RESPONSE TO REQUEST FOR ADDITIONAL INFORMATION

US-APWR Design Certification

Mitsubishi Heavy Industries

Docket No. 52-021

Figure 5-7 Periodic Surveillance of Protection Functions Implemented via Binary Sensors Connected to PSMS (Increasing Process)

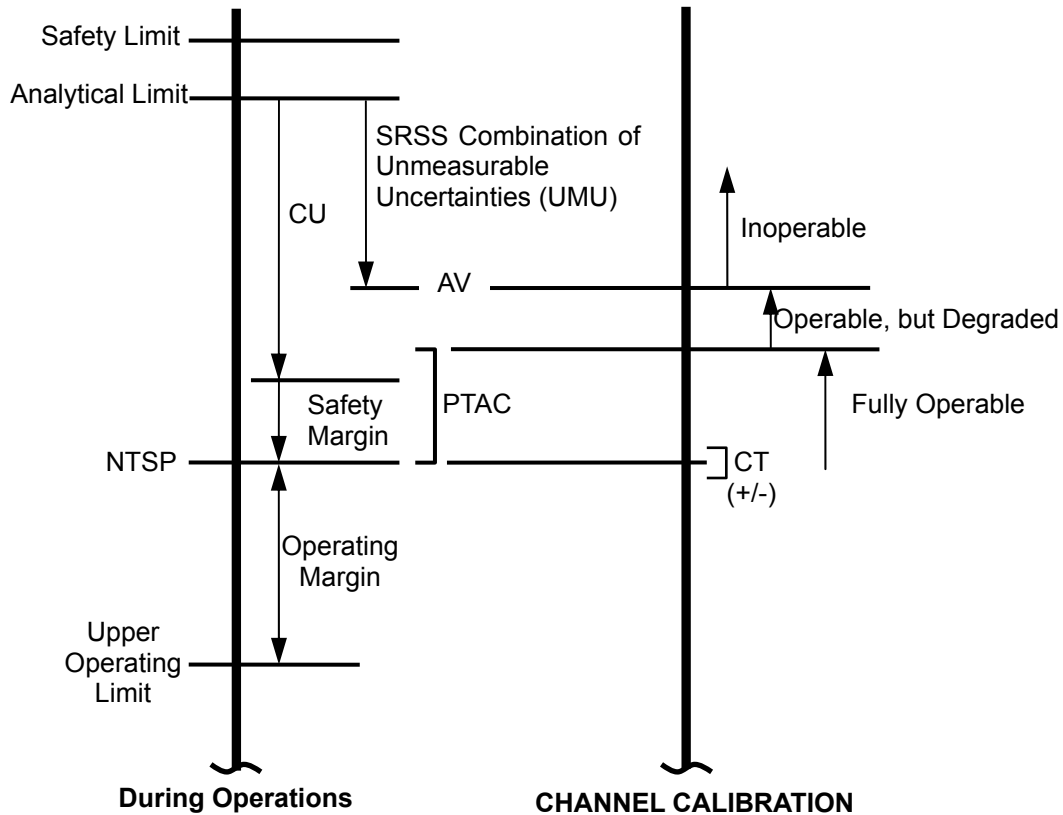
MHI had revised sections 5.3.1 and 5.3.2 of MUAP-09022 and added a new section 5.3.2.2 with a new Figure 5-7 in MUAP-09022 Rev. 2.

Figure 5-7 illustrates the relationships between the trip setpoint and other parameters for protection functions implemented via binary sensors connected to digital PSMS channels. These functions are 1) reactor trip (RT) on turbine trip (TT) via low turbine oil pressure (pressure switch) and 2) Loss of Power (LOP) signal (UV relay).

The AV is used during channel calibration to determine operability. The PTAC term is described in Section 5.4. PTAC is used (relative to NTSP) to determine degradation, thus avoiding the use of excessive tolerances as required by Reference 3.2.4 (RIS 2006-17). Plant procedures will reflect this approach (increasing process; invert for decreasing process):

- If the as-found trip value is less than $NTSP + PTAC$, then the channel is fully operable
- If the as-found trip value is greater than $NTSP + PTAC$ and less than AV, then the channel is operable but degraded, and corrective action is required to restore the channel to within specifications.
- If the as-found trip value is greater than AV, then the channel is inoperable, and corrective action is required, including those actions required by 10 CFR 50.36 when automatic protective devices do not function as required.

Figure 5-4 Channel Calibration on Analog Measurements

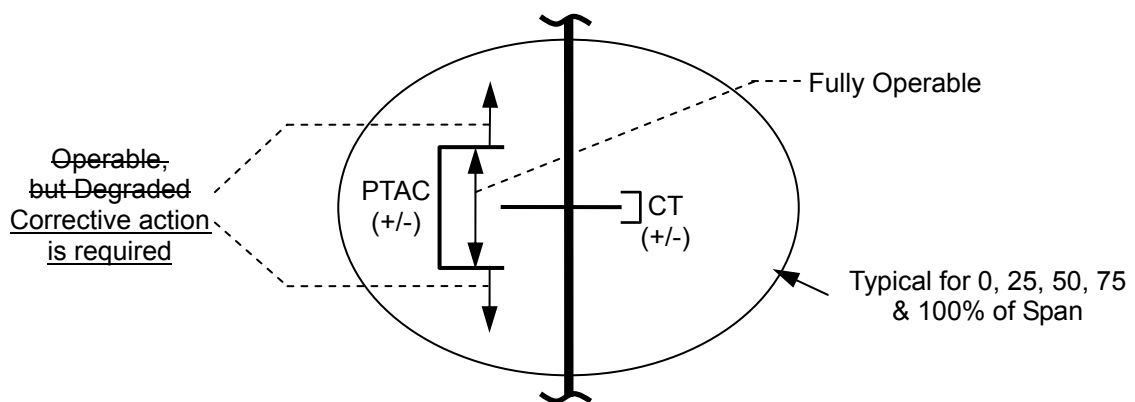
MHI will revise Section 2.0, 5.3.1, 5.3.2, 5.3.2.2 and 5.4 in MUAP-09022 Rev.3 as follows:

Surveillance testing and calibration of analog bistable channels is performed in two overlapping steps (i.e., Step 1 – Channel Calibration, Step 2 - COT ~~—Analog~~)

Figure 5-5 Periodic Surveillance of Protection Function Implemented via Analog Bistables (Increasing Process)

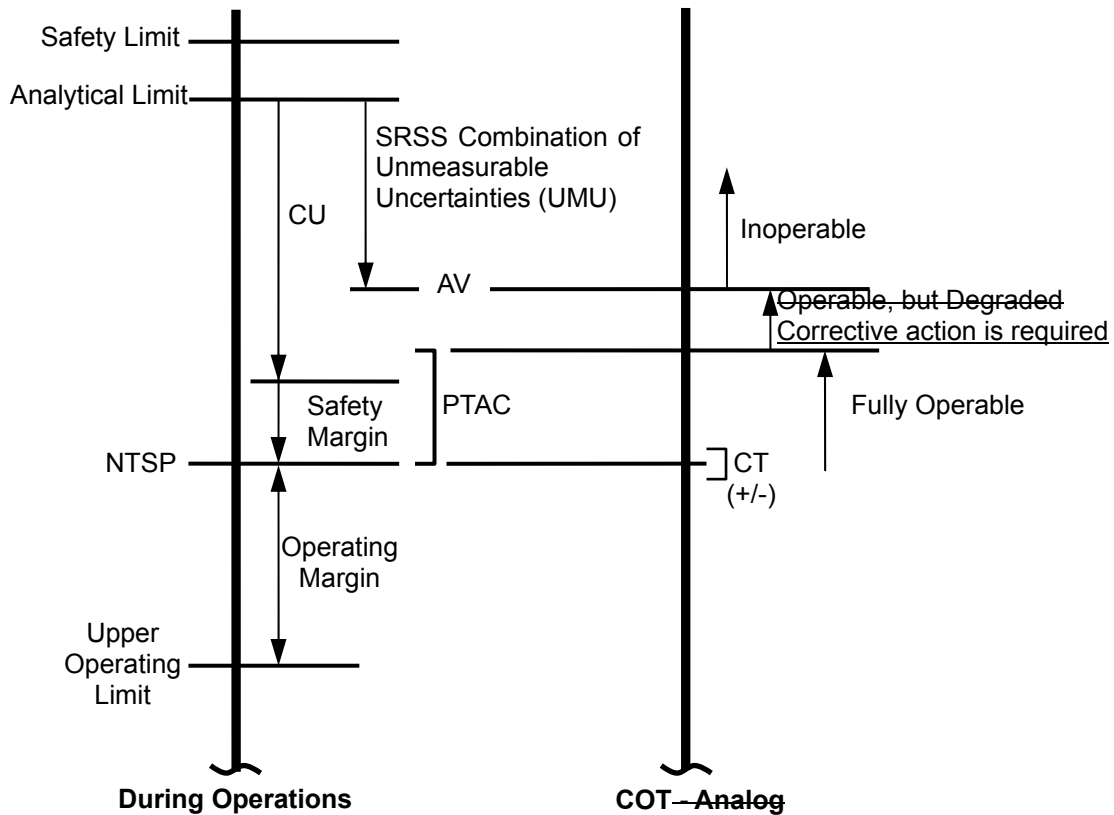
Figure 5-5 illustrates the relationships between the trip setpoints and other parameters for protection functions implemented via conventional analog bistables. This figure illustrates how NTSP is derived, and how PTAC and AV are related to the trip setpoints. The protection functions implemented via analog bistables are associated with the DAS, ~~the reactor trip on a turbine trip (TT) function and the loss of power (LOOP) signal, e.g., under voltage (UV).~~

NTSP. COT — Analog for an increasing process trip function is illustrated in Figure 5-5. The Figure 5-5 illustrates the relationships between the NTSP and other parameters for protection functions implemented via conventional analog bistables. This figure illustrates how NTSP is derived, and how PTAC and AV are related to the NTSP.

- If the as-found trip value is greater than NTSP + PTAC and less than AV, then the channel is ~~operable but degraded~~, and corrective action is required to restore the channel to within specifications.

Figure 5-6 Periodic Surveillance of Protection Functions Implemented via Digital Bistables

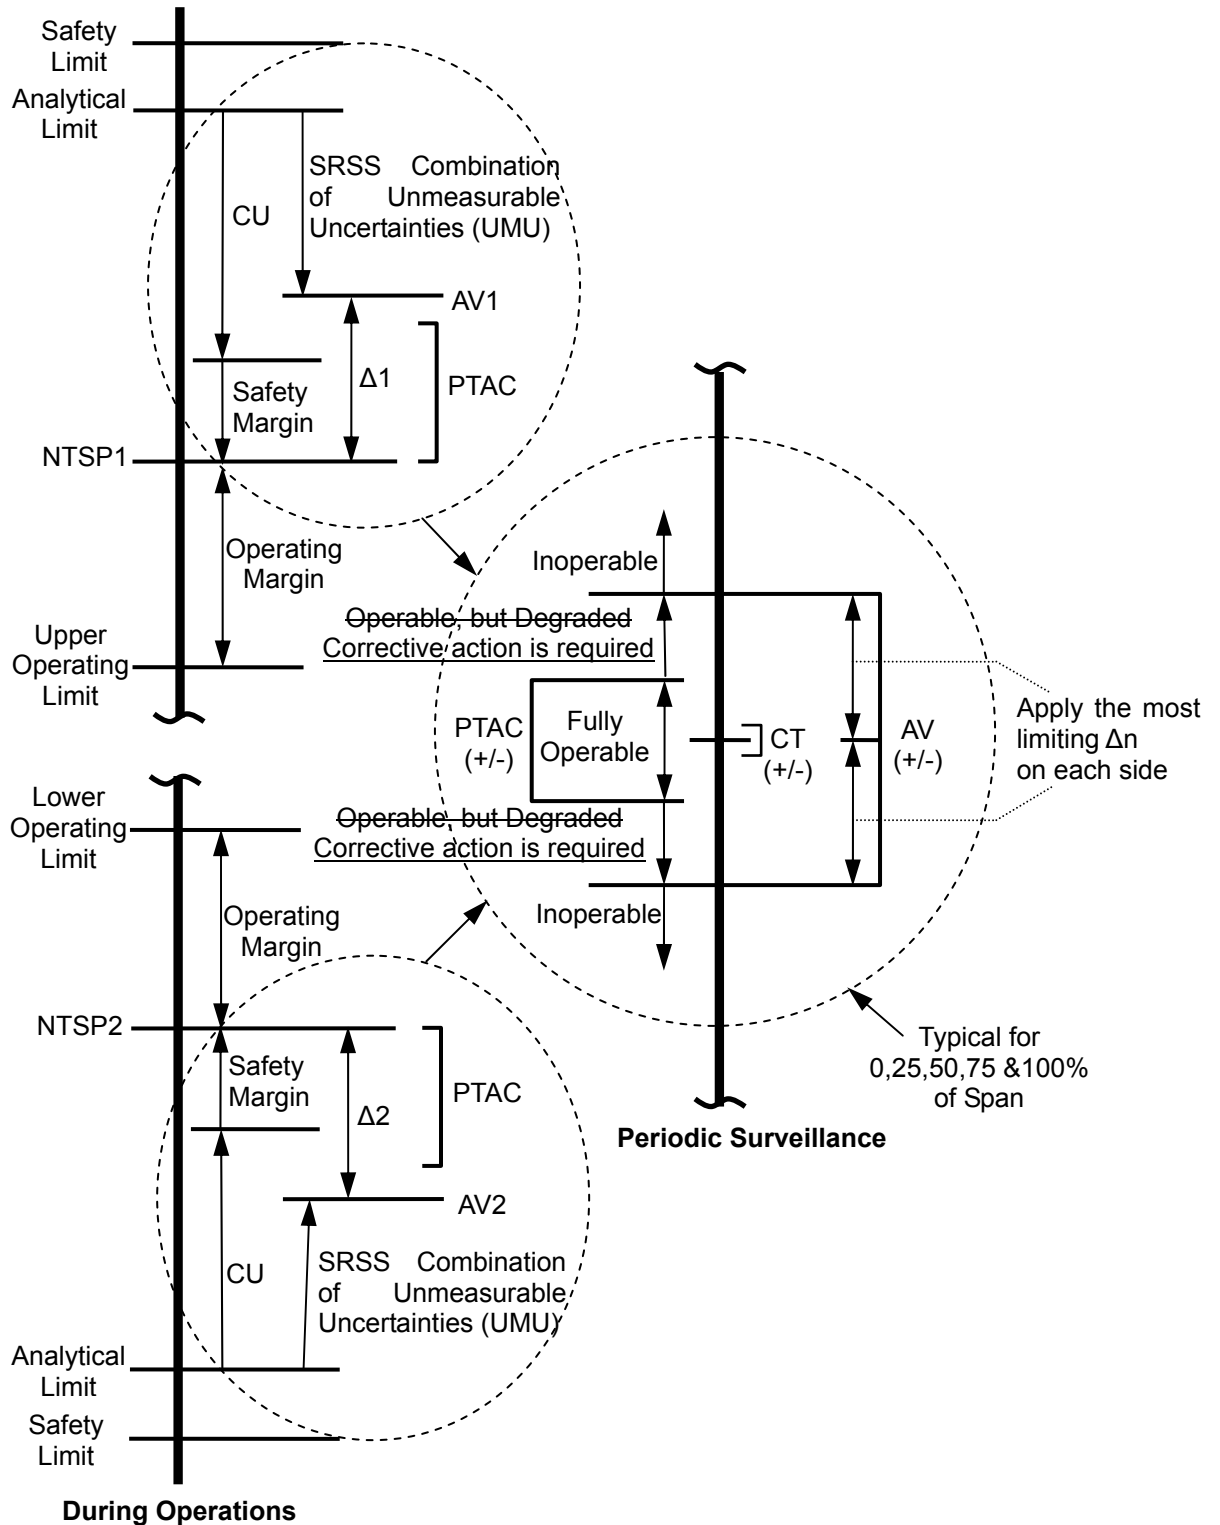
Figure 5-6 illustrates the relationships between the trip setpoint and other parameters for protection functions implemented via digital bistables. This figure illustrates how the NTSP is derived, and how PTAC and AV are related to the calibration setting. The protection functions implemented via digital bistables in the US-APWR are all those that are not implemented via analog bistables (identified above) and those not originating as binary measurements (identified below).

- If any as-found calibration setting value is outside the two-sided limits of (Calibration Setting \pm PTAC), but inside the limits of (Calibration Setting \pm AV), then the channel is ~~operable but degraded~~, and corrective action is required to restore the channel to within specifications.

Figure 5-7 Periodic Surveillance of Protection Functions Implemented via Binary Sensors Connected to PSMS (Increasing Process)

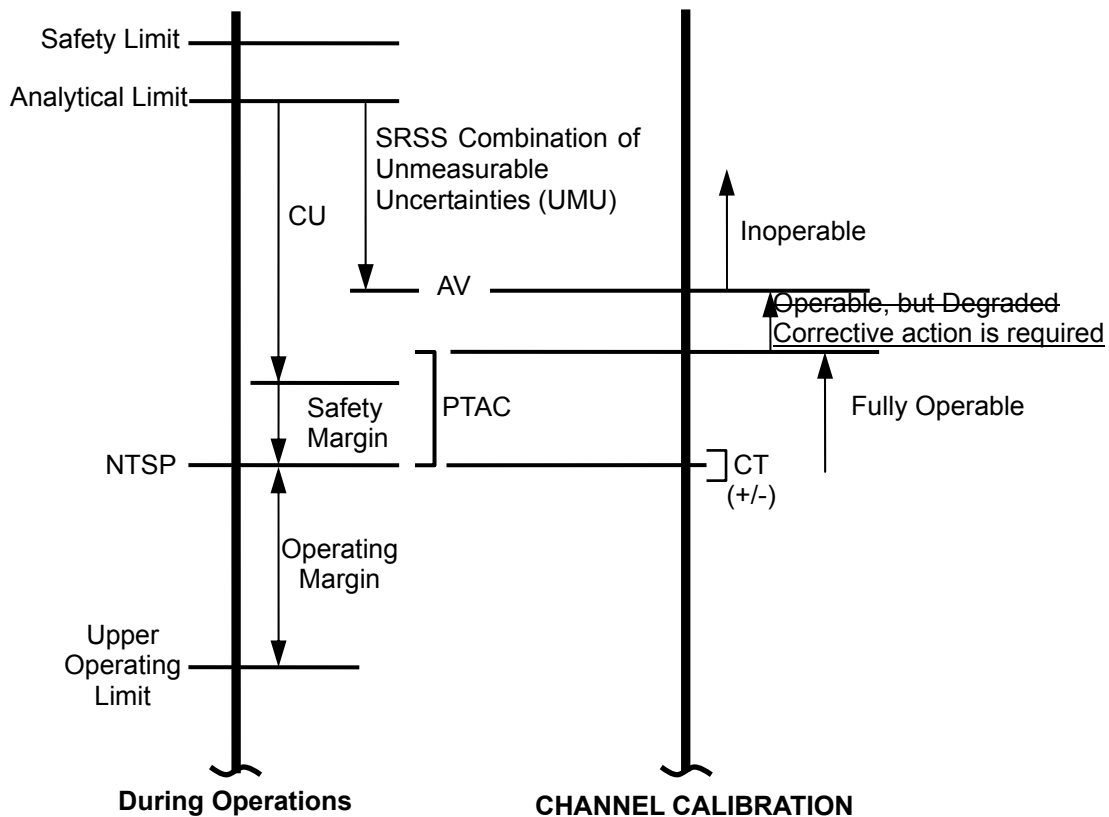
Sections 5.3.1 and 5.3.2 of MUAP-09022-P(R1) are incorrect. In Rev. 2, MHI revised section 5.3.1 to clearly define the setpoint methodology for analog bistables, and 5.3.2 was revised to clearly define the setpoint methodology for digital bistables. In addition, a new section 5.3.2.2 with a new Figure 5-7 was added to Rev. 2 to clearly describe the setpoint methodology and surveillance method for binary sensors.

Figure 5-7 illustrates the relationships between the trip setpoint and other parameters for protection functions implemented via binary sensors with drift potential connected to digital PSMS channels. These functions are 1) reactor trip (RT) on turbine trip (TT) via low turbine oil pressure (pressure switch) and 2) Loss of Power (LOP) signal (UV relay).

- If the as-found trip value is greater than NTSP + PTAC and less than AV, ~~then the channel is operable but degraded, and corrective action is required to restore the channel to within specifications.~~
